HUNTINGTON BEACH DESALINATION PLANT RESPONSE TO REQUEST FOR INFORMATION REGARDING ENVIRONMENTAL ANALYSIS OF THE 2018 DIFFUSER MODIFICATIONS

To: Josie McKinley, Poseidon Water
From: Joe Monaco, Dudek
Caitlin Munson, Dudek
Subject: Huntington Beach Desalination Plant Response to Request for Information
Regarding Environmental Analysis of the 2018 Diffuser Modifications
Date: November 27, 2018
Attachment(s): Appendix A: Bracketed California State Lands Commission Letter: Proposed
Diffuser Change, Poseidon Huntington Beach (PRC 1980.1)
Appendix B: November 2018 Huntington Beach Desalination Plant 2018
Diffuser Modifications Environmental Analysis

*California State Lands Commission Letter:
Proposed Diffuser Change, Poseidon Huntington
Beach (PRC 1980.1)*

1 PLAN
C1

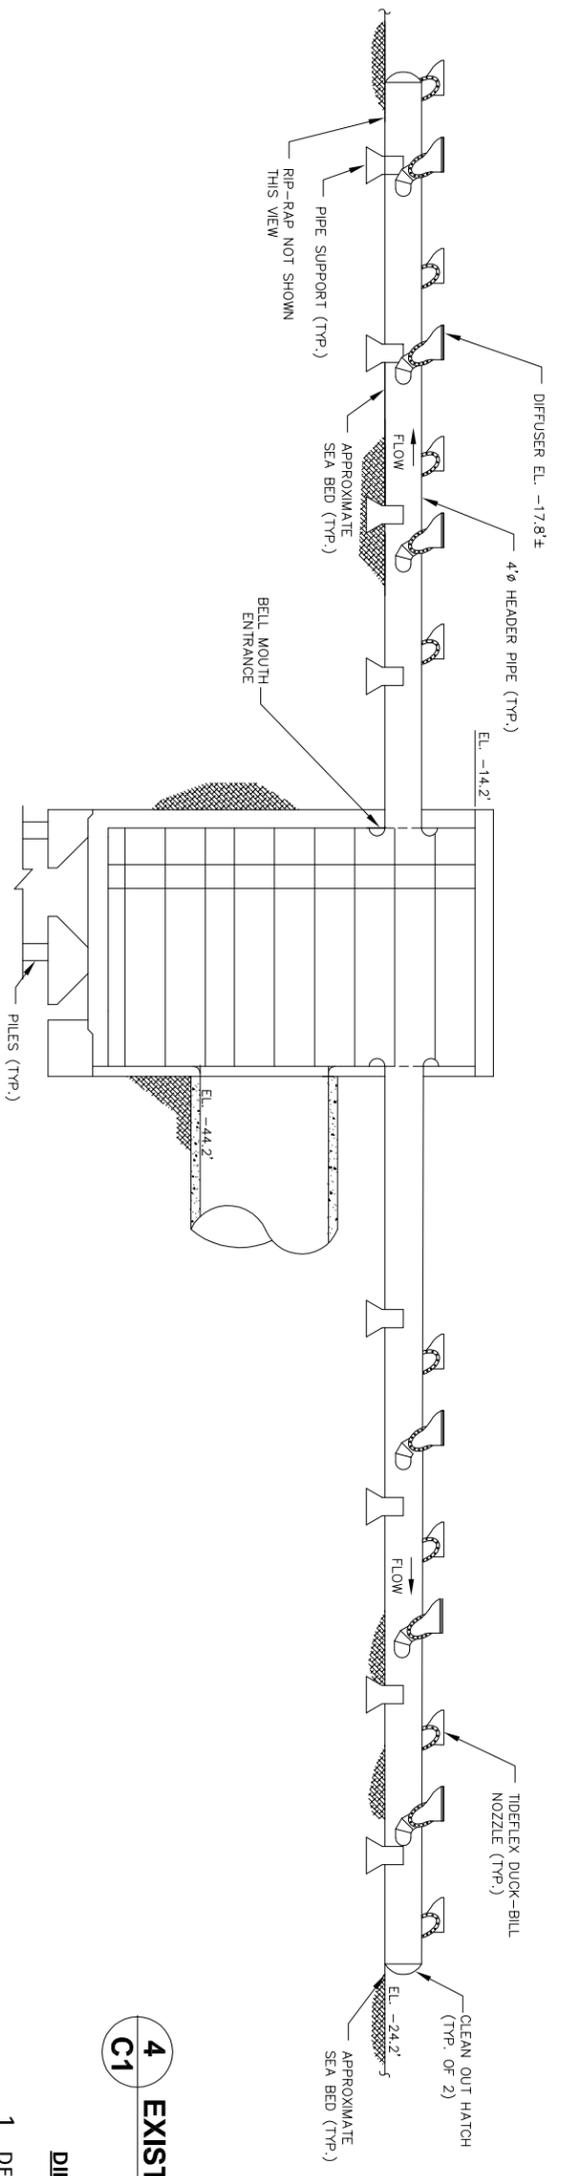
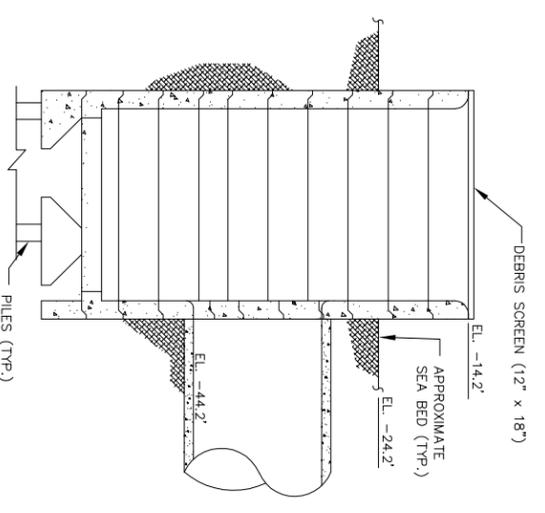
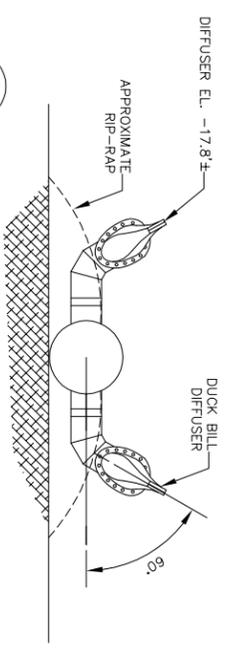
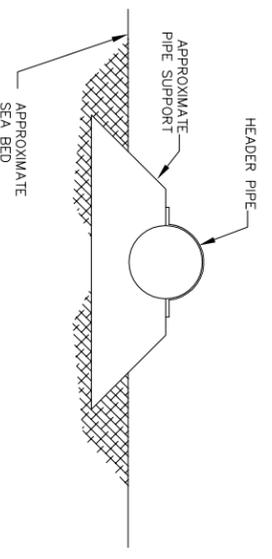
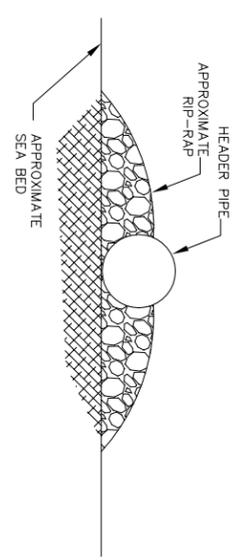
In addition, the diffuser design modification results in a different riprap footprint from what was evaluated in the Supplemental EIR. It appears that the current riprap located on the seaward side and half of the adjacent side of the diffuser tower would be removed and later placed around the linear diffuser, but that there would be no riprap replaced around the outfall tower,³ also shown in the footprint in Figure 2 of the Dudek Memo. The Supplemental EIR only showed a general outline of the new riprap footprint, but this was because the existing tower would simply be centered within an expanded area. The new diffuser design seems to propose a different riprap configuration around the tower, and Commission staff requests that the Applicant provide the Water Boards with a more detailed figure that identifies the outfall tower, the connecting pipeline, and the linear diffuser locations within the riprap footprint.

4. The approximate limits of riprap are shown in the Preliminary Brine Discharge Linear Diffuser Drawing and Comparison of Existing Discharge Tower Footprint, 2017 SEIR Diffuser Footprint and Proposed 14 - Port Linear Diffuser Footprint Schematic , attached as Appendix B- Figures 1 & 2. These figures show the limits of riprap placement relative to the linear diffuser pipeline, and the existing discharge tower.

10. The revised Alden Brine Discharge Linear Diffuser construction drawing shows the approximate riprap footprint length as 226 feet and the length of the linear diffuser pipeline and the existing discharge tower as 208 feet (see Figure 1 of Appendix B). Therefore, the *August 2018 Diffuser Modifications Environmental Analysis* assumptions have been revised accordingly in the November 2018 analysis. The August 2018 analysis assumed that the riprap footprint would be approximately 212 feet long and the length of the linear diffuser pipeline is 194 feet long, consistent with the original Alden Brine Discharge Linear Diffuser construction drawings.

SLC SEIR Figure 2-8 Existing and Proposed Discharge Structure Foot Print with Rip-Rap

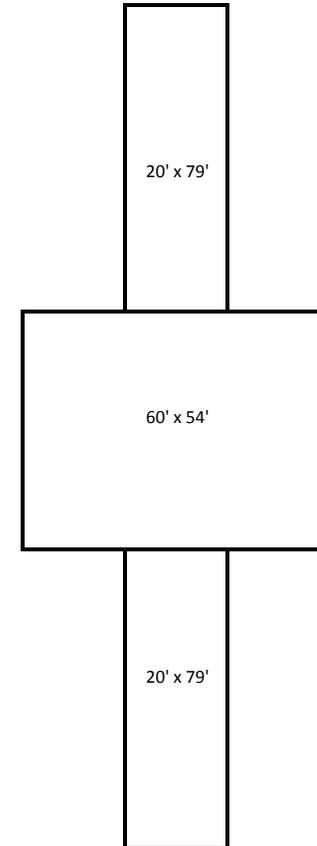
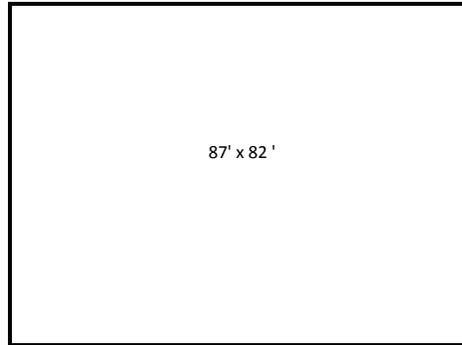
The Supplemental EIR evaluated a diffuser design that placed the three ports on top of the existing outfall tower and expanded the riprap footprint around the structure. This design fell within the existing Commission lease area. Commission staff understands that the new diffuser design will set the linear diffuser away from the existing outfall tower. Please have the Applicant provide design drawings that show the revised design relative to the existing lease area. Any portion of the new design that extends beyond the existing land description must be included in the Applicant's lease amendment.

2. In response to the Commission staff's inquiry, regarding the location of the diffuser lying outside of the lease area, Poseidon has re-aligned the 14-port linear diffuser with the existing tower, which lies within the lease area. Poseidon understands that the revised diffuser design requested by the Regional Board will require an amendment to the lease approved by the State Lands Commission in October 2017. Poseidon plans to seek that amendment after the Regional Board approves the final diffuser design.
